Docket Items #4 & #5
BAR CASE #2017-0165
& 2017-0166

BAR Meeting
June 20, 2018

ISSUE: Certificate of Appropriateness for Alterations, Reapproval of Permit to Demolish & Re-approval of Certificate of Appropriateness for Addition

LOCATION: 109 Duke Street

Figure 3: Entry portico at 212 South Fairfax

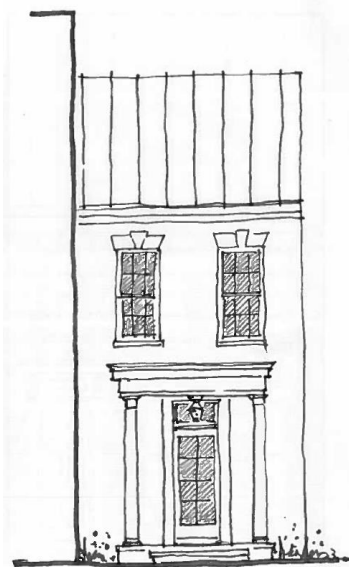
In working with the applicant, staff suggested an alternative smaller portico entrance, such as the one at 212 S Fairfax shown in Figure 3 and shown in a staff sketch in Figure 4, rather than the proposed a full width porch. While this has the advantage of being a more delicate scale and

slightly less formal, and specifically of not touching the historic wall to the west, the applicant believed it called too much attention to this door as a primary entrance.

PROPOSED FRONT ELEVATION

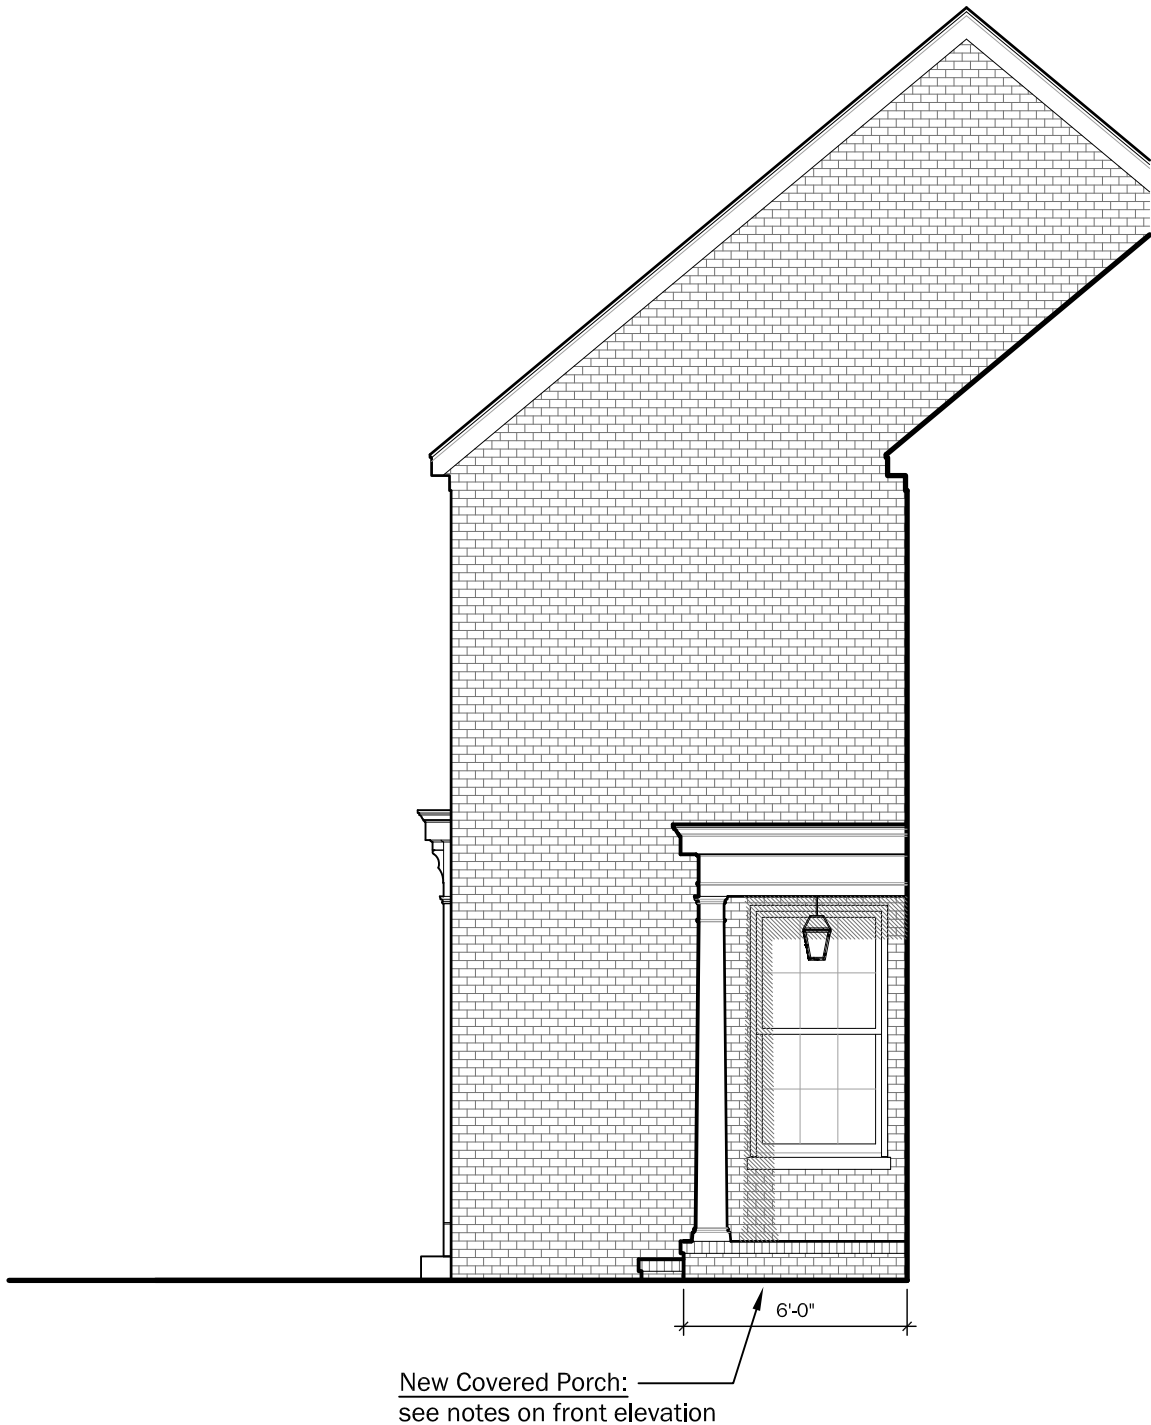
Since the last time the BAR saw the proposed front entrance feature, the design of the front porch has evolved slightly to become more architecturally subtle and secondary to the main historic house fronting on Duke Street, per the BAR's direction that the later addition should not be visually prominent. To achieve this, the architect altered the spacing of the porch columns from the previous submission and removed the existing decorative fanlight, replacing it with a simpler door and rectangular transom with simple trim (Figure 1 & Figure 2). These changes allow the 1980s addition to read as a later addition and to not compete architecturally with the well-proportioned historic Federal townhouse.

Staff appreciates that the applicant has continued to evolve the design of this new feature, making a concerted effort to balance making the true entrance to the house visible and inviting while still retaining the prominence of the historic main house. If the existing addition were proposed today, staff would suggest a less formal and more architecturally compatible background addition, rather than the high-style addition that was constructed in the 1980s.

However, the full-width porch abuts the historic house on the west, potentially damaging the historic brick wall. Therefore, applicant has stated that the porch will not be bolted to the east wall of the historic structure and that any flashing will only be inserted into a mortar joint, making the porch easily reversible with no damage to the historic structure. With this condition, to be approved by staff prior to issuance of a building permit, staff recommends approval of the application.

4. The porch may not be bolted to the east wall of the historic structure and any roof flashing will only be inserted into a mortar joint, making the porch easily reversible with no damage to the historic structure; and,

5. Provide detailed construction drawings of the proposed front door, transom and trim prior to the submission of the building permit, with final approval by staff.
